Official Transcript of Proceedings
NUCLEAR REGULATORY COMMISSION

Title: Advisory Committee on Reactor Safeguards
Materials, Metallurgy and Reactor Fuels

Date: Wednesday, September 23, 2009

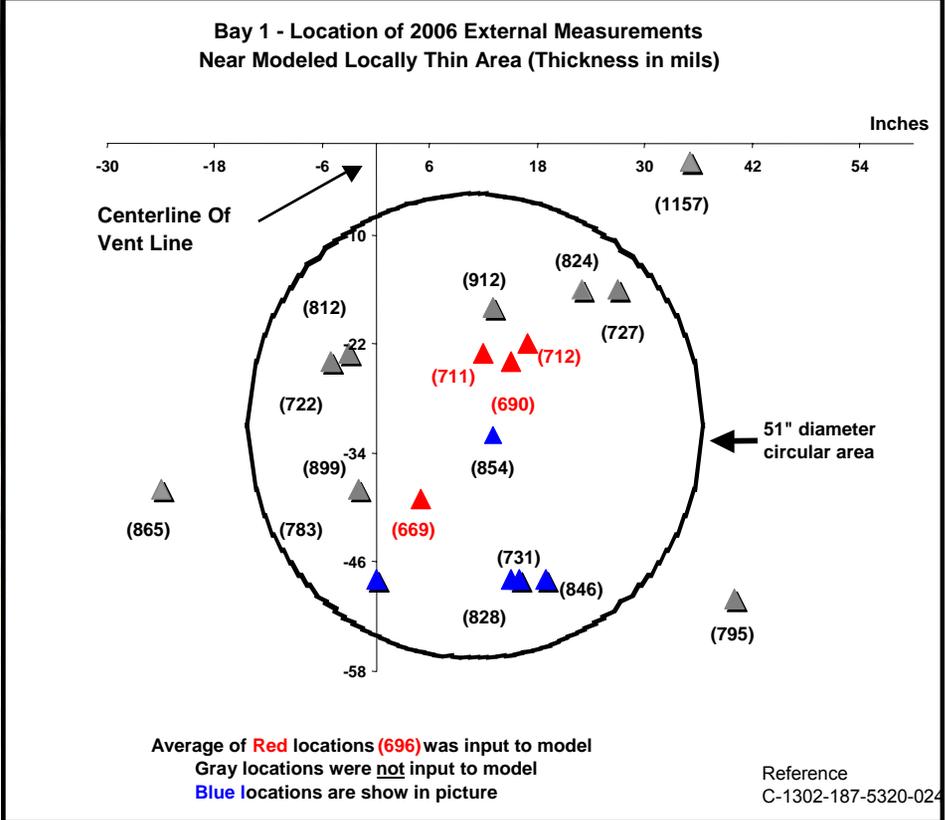
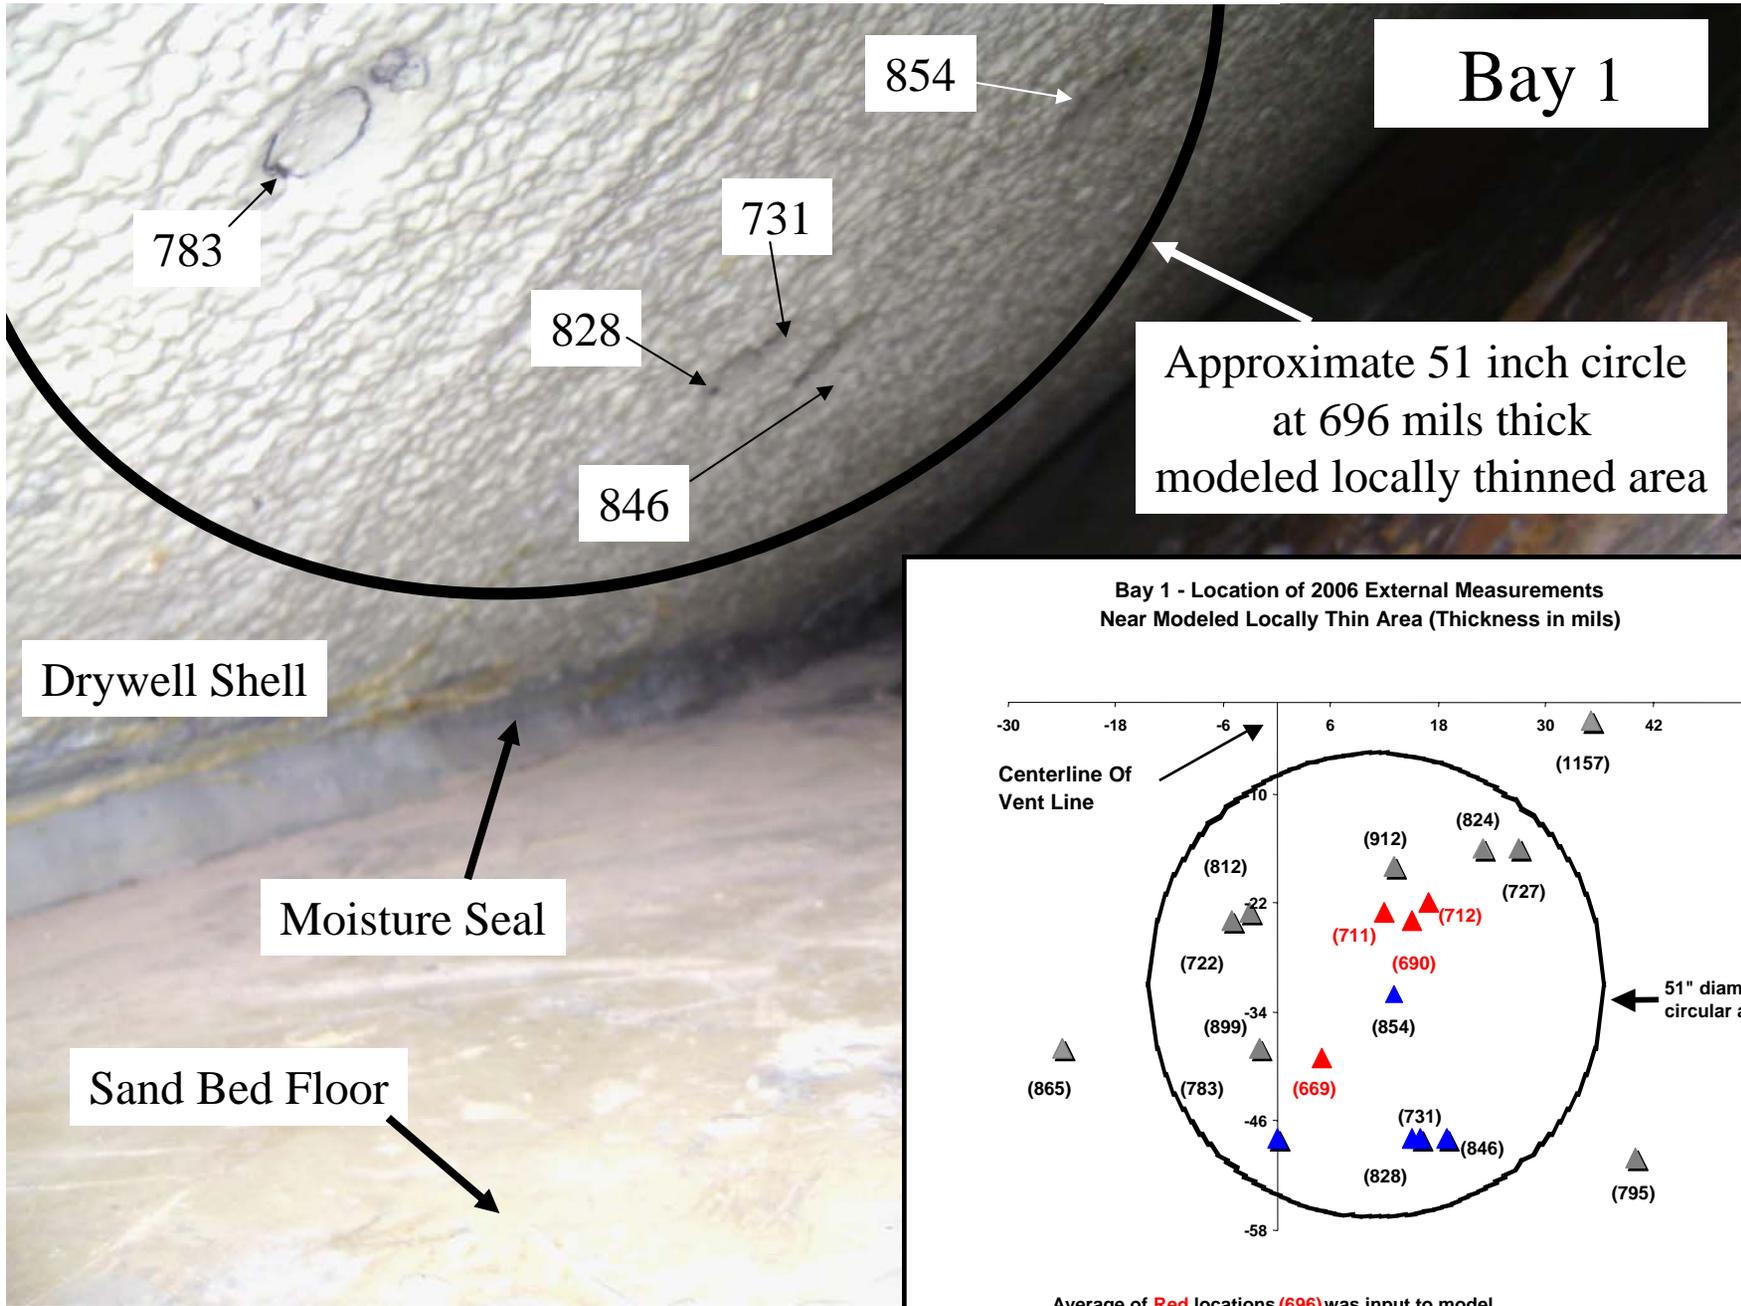
- ✓ Why are the External UT points considered biased thin?
- ✓ Response:
 - The External UT Points were identified visually as thin areas for further evaluation. The areas were also ground to permit UT measurement. Therefore, they are biased thin.

- ✓ After the sand and corrosion byproducts were removed from the sandbed bays, the thinnest locations in each bay were identified.
- ✓ Each bay was visually inspected and the thinnest local spots were investigated both visually and using UT measurements.
- ✓ Approximately 100 locations were identified and mapped.
- ✓ The external surface of the shell was rough, requiring most of the locations to be ground down to create small flat surfaces so the UT probe could be placed perpendicular to the shell wall.
 - This resulted in small 1 to 2 inch diameter dimples in the surface with relatively thinner local areas (biased thin) that were then measured by UT.
 - Micrometer characterization showed that the grinding process may have removed up to 100 mils.
 - Between the individual External UT points, the shell is thicker.

The External UT points are biased thin. They were used to develop the locally thinned modeled areas. It is not appropriate to use these individual measurements to determine general area thicknesses.

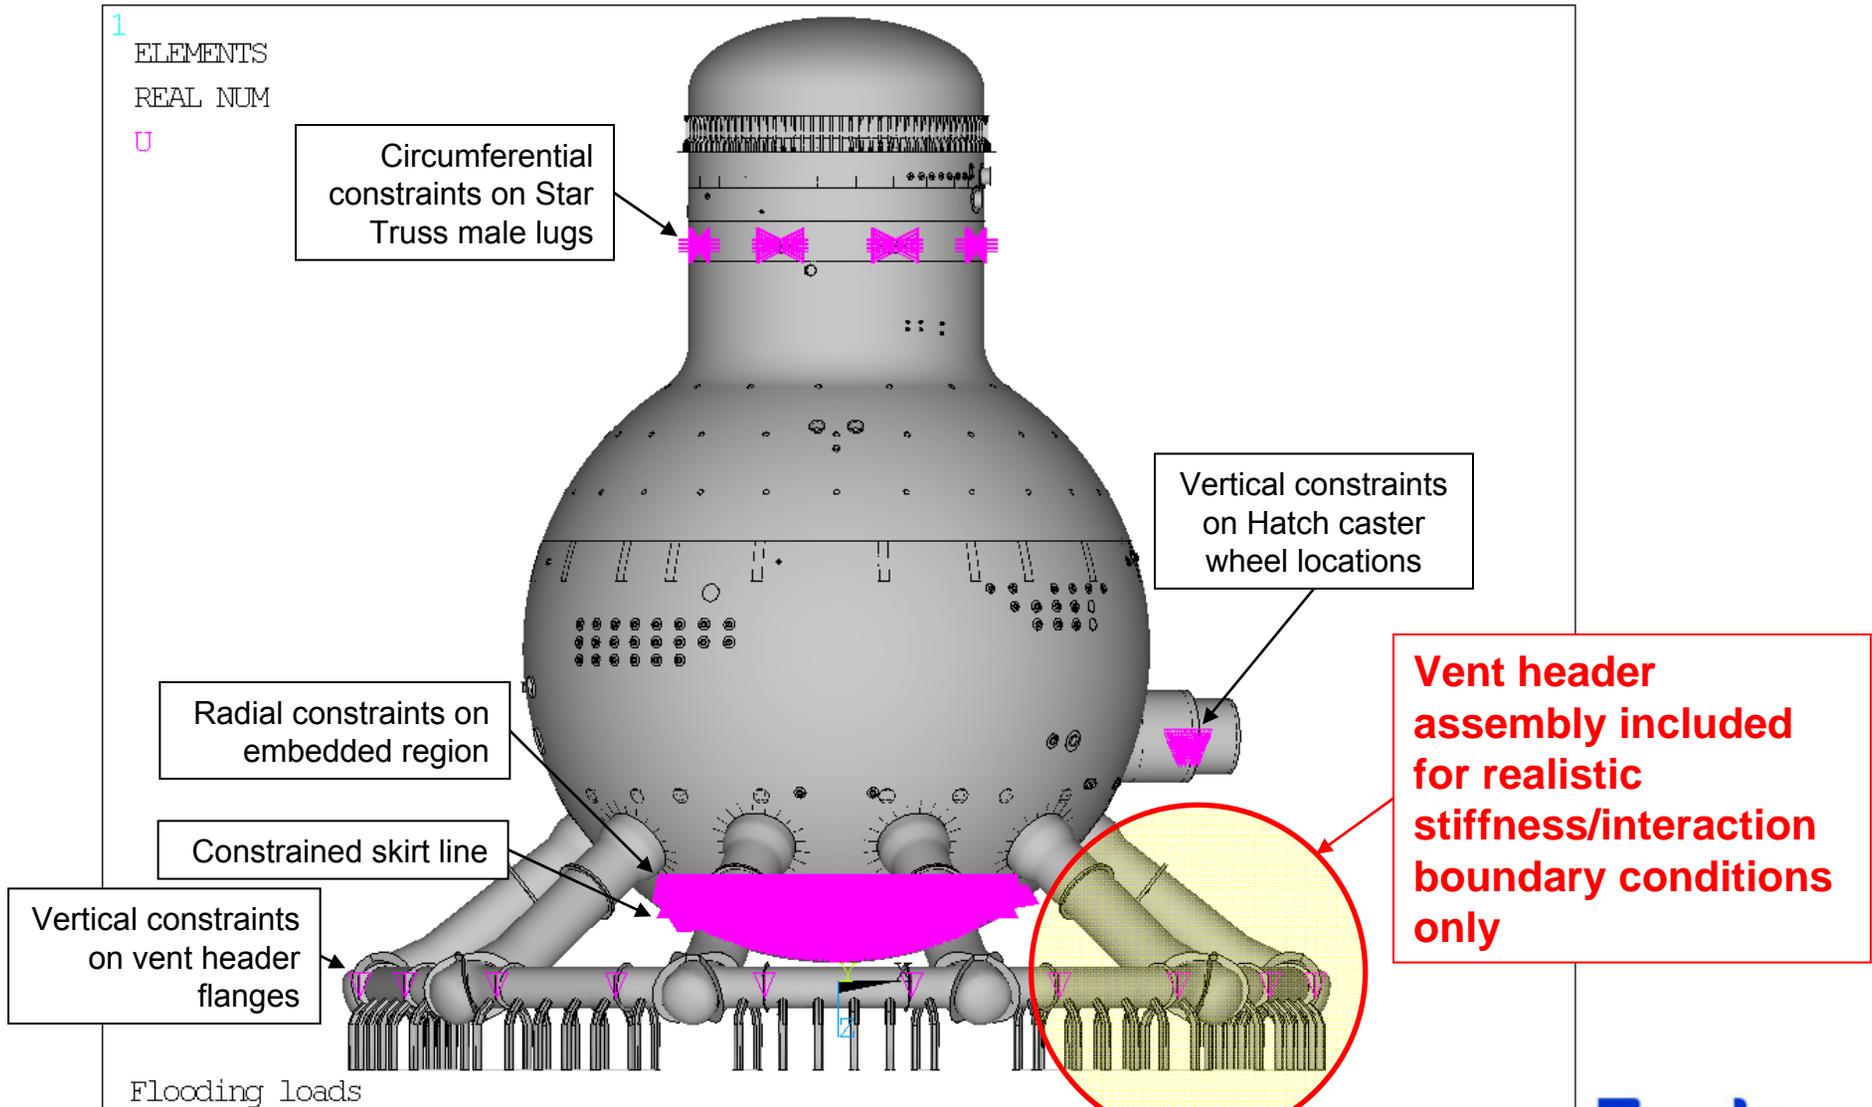
- ✓ Describe specifically the modeling of the vent header boundary condition. Is this boundary condition appropriate as to the effect on the shell? Will the downcomer vents buckle?
- ✓ Response:
 - The vent header boundary condition modeling is appropriate and the boundary condition does not provide added benefit to the shell analysis
 - The vent pipes/header will not buckle before the shell

- ✓ Detailed modeling of the vent headers/downcomers is included for realistic representation of stiffness/interaction of components attached to the drywell shell
 - Similar to the use of stiffness matrix as boundary conditions
- ✓ Detailed modeling reduces conservatism in stress/buckling results
 - Account for realistic load transfer
 - Alternate simplified approach is to model with estimated boundary conditions at vent pipes/vent header interface location
